適航指令發布單

民航局AD編號 AD number	CAA-2015-11-005H	發布日期 Date issued	2025/07/21
適用之航空產品 Applied to (models, serial numbers or part numbers, as applicable)	This AD applies to the following helicopters, when equipped with a Goodrich hoist having a Part Number (P/N) as listed in Table 1 of this AD: Leonardo AW109SP, AB139, AW139 and AB412 (all models) helicopters, all serial numbers (s/n); BTI 212, 214 and 412 helicopters (all models), all s/n; BTCL 429 and 430 helicopters, all s/n; AH AS 365 N3, AS 332 L2 and EC225 LP helicopters, all s/n; AHD MBB-BK117 C-2, EC135 and EC635 (all models) helicopters, all s/n; MDHI MD900 helicopters, all s/n; and Sikorsky S-61 (all models), S-76A, S-76B, S-76C and S-92A helicopters, all s/n.		
主旨摘要 Subject	Equipment / Furnishings - Hoist - Test / Replacement		
民航局 CAA <input type="radio"/> 本國產品 Native product <input type="radio"/> 其他個案 Other	<div>設計國民航主管機構 Original Authority</div> <div><div><input type="radio"/> FAA <input checked="" type="radio"/> EASA <input type="radio"/> Brazil <input type="radio"/> Transport Canada Civil Aviation <input type="radio"/> DGAC</div><div><input type="radio"/> Germany LBA <input type="radio"/> CAA-NL <input type="radio"/> UK CA

Figure 1

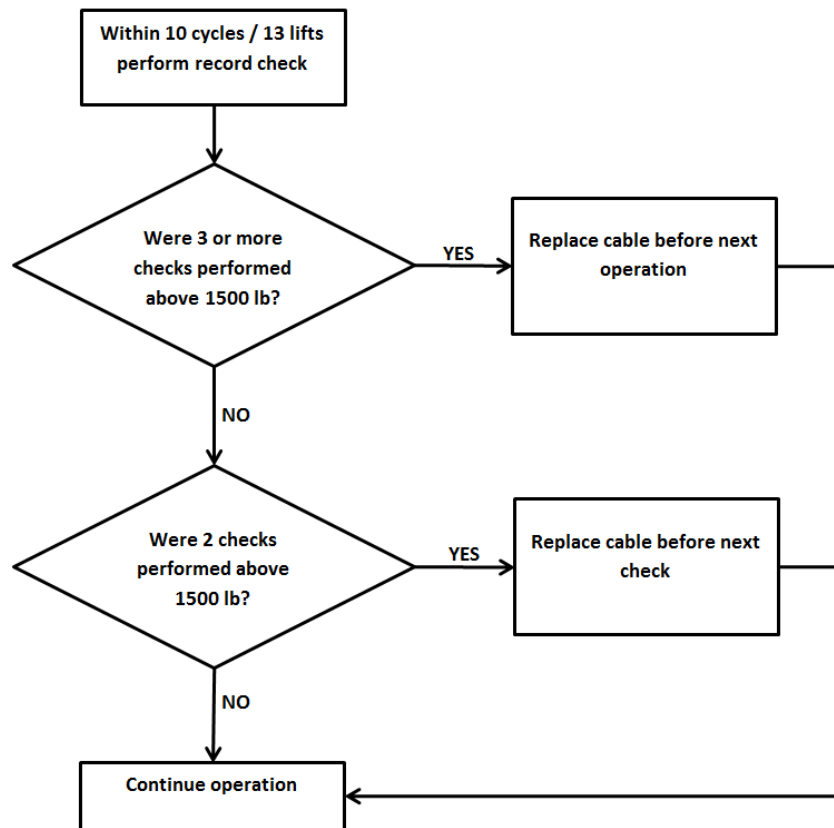
- (1) Within 10 hoist operating cycles or 13 hoist lifts (as applicable, see Note 1 of this AD) after 21 November 2015 [the effective date of the original issue of this AD], determine the P/N of the hoist installed on the helicopter and, if a Goodrich hoist is installed with a P/N listed in Table 1 of this AD, accomplish a records check to determine whether, during any previous hoist load check/test, a cable was load-tested (average of 5 pulls) at 1 500 lb [680 kg] or more. If any cable is identified to have exceeded this limit during three or more hoist load checks/tests, before next hoist operation, replace the affected cable with a serviceable cable. If any cable is identified to have exceeded this limit during two hoist load checks/tests, before the next hoist load check/test, replace the affected cable with a serviceable cable. For replacement of a cable, see Figure 1 (flowchart) of this AD.
